Our Reference: **PT22005**

Planning Proposal for 171 lot residential subdivision – Lot 24 DP1119250 – 4273 Goulburn Road, CROOKWELL

Response Report

Figure 4 – Revised Trip Distribution of Potential Development Generated Traffic

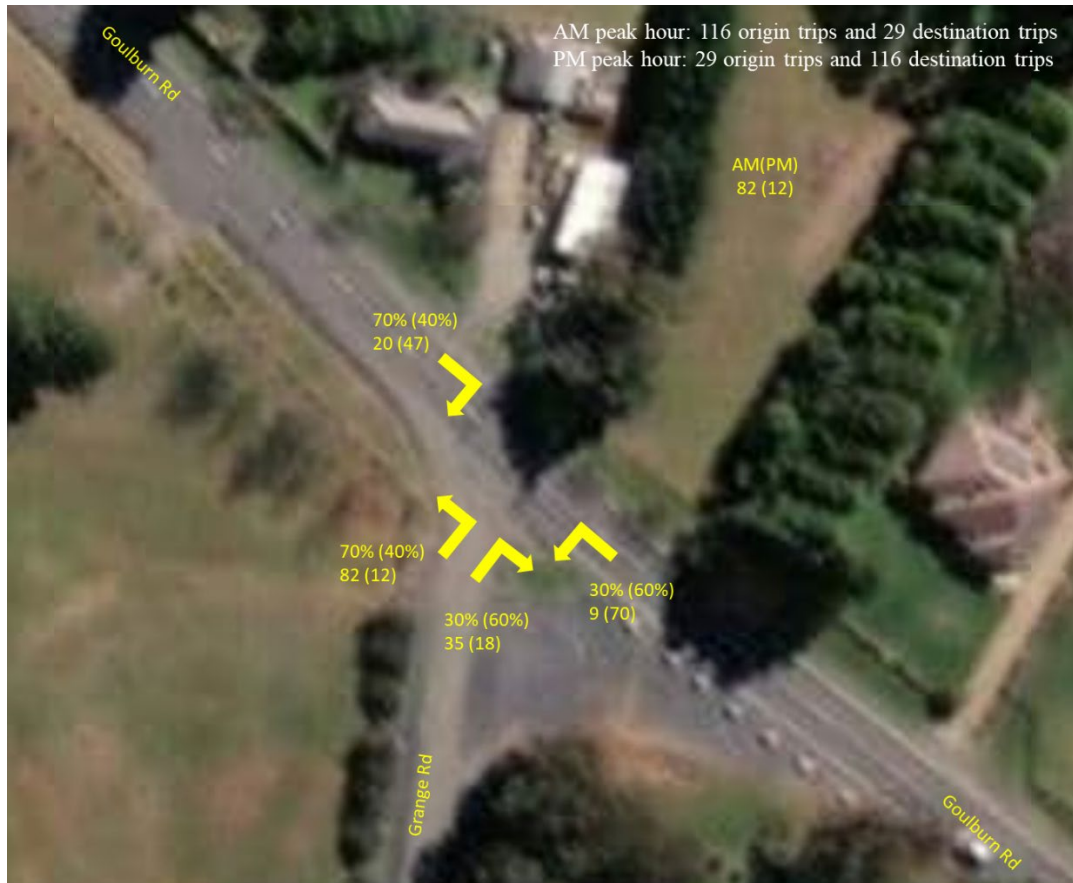
- *The trip distributions that are presented in the Traffic Impact and Parking Assessment need to be justified. This would include an explanation of the assumed travel patterns to access services and facilities in Crookwell and Goulburn.*

As a sensitivity test, the generated trips of the development (adopting the same conservative approach of *all* traffic passing through the intersection of Goulburn Road / Grange Road) have been distributed adopting the same mid block distribution of trips in Goulburn Road. This would result in the following additional trips by movement at the intersection as shown in **Figure 4**.

From **Table 2** it is noted that the sensitivity test of an alternative distribution of generated trips of the development (conservatively assuming all generated traffic passes through the intersection of Goulburn Road / Grange Road) does not result in any difference in the future intersection operating conditions compared to that which was found in the Motion Traffic Engineers report.

Thus, given the generally low traffic volumes in Goulburn Road and of the potential development of the site subject to rezoning approval, the assumed distribution of trips generated by the proposal would not markedly change the forecast future intersection operating conditions of Goulburn Road / Grange Road.

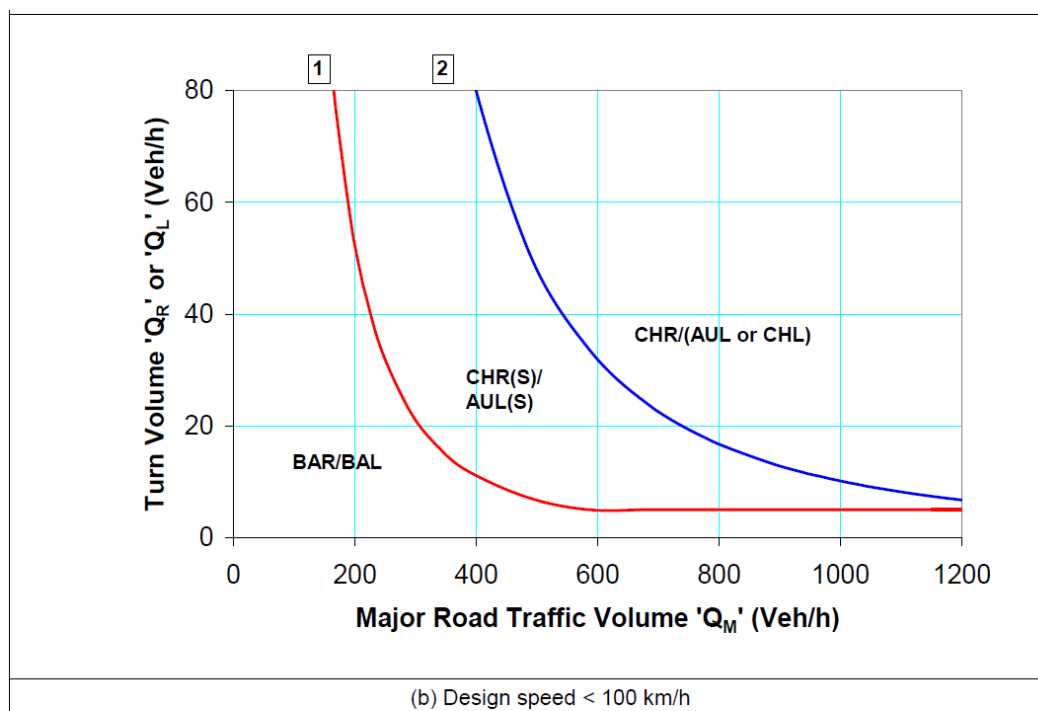
- *TfNSW highly recommends utilising Grange Road to provide access to the proposed subdivision, as per the Traffic Impact and Parking Assessment, if possible.*
 - o *The proponent needs to discuss with Council on whether Grange Road is suitable for access to the subdivision. TfNSW will require that the road be suitable to allow simultaneous traffic movements, and to meet the appropriate council standards and have appropriate drainage if it is to be utilised as access from Goulburn Road.*
 - o *TfNSW is open to further consultation with the proponent and Council, especially on the appropriate access to and from the proposed development.*

On the matter of what would be considered an appropriate pavement width for Grange Road, the Australian Model Code For Residential Development (AMCORD) suggests the following carriageway widths for local streets which allow for 300 – 2,000 vehicles per day:

Therefore, a pavement width of 5.5m would be considered appropriate in Grange Road to serve the subject site in the future along with considerations at intersections which allow for kerb returns which accommodate waste vehicles.

Figure 5 – Five (5) Year Crash Data Near Goulburn Rd / Grange Rd

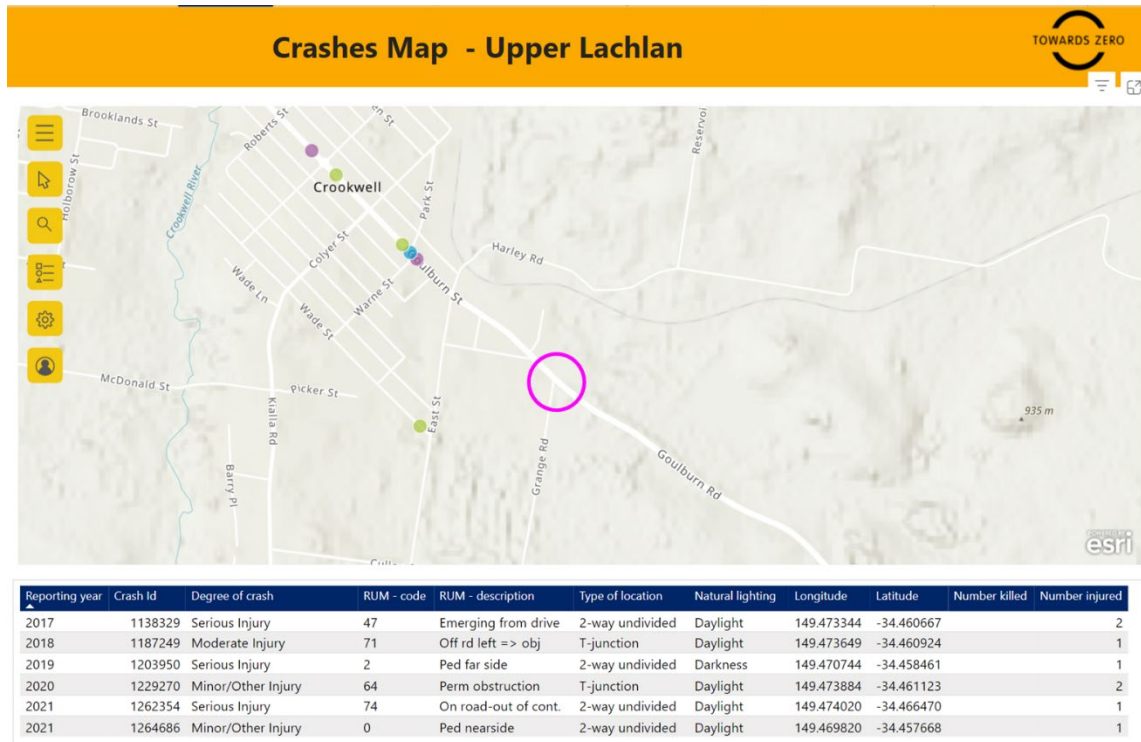
- *Road safety assessment including details on crash history and a sight distance assessment at the local road connections with a classified road. In this instance, there will need to be an assessment of the Goulburn Road/Grange Road intersection. To demonstrate that appropriate sight distances are available, TfNSW will require a scaled concept plan showing the sight distances available and what is required at the access as well as the identification of appropriate mitigation measures to address any concerns;*

The five (5) year crash data in the vicinity of the intersection of Goulburn Road / Grange Road is shown below in **Figure 5**. This confirms that no accidents have occurred at the intersection in the last five years.

On the matter of the sight distance assessment, traffic exiting Grange Road is afforded an available sight distance to traffic in Goulburn Road in both directions of some **230m** which far exceeds the minimum sight distance requirements for a local intersection within a 50km/hr posted speed limit.
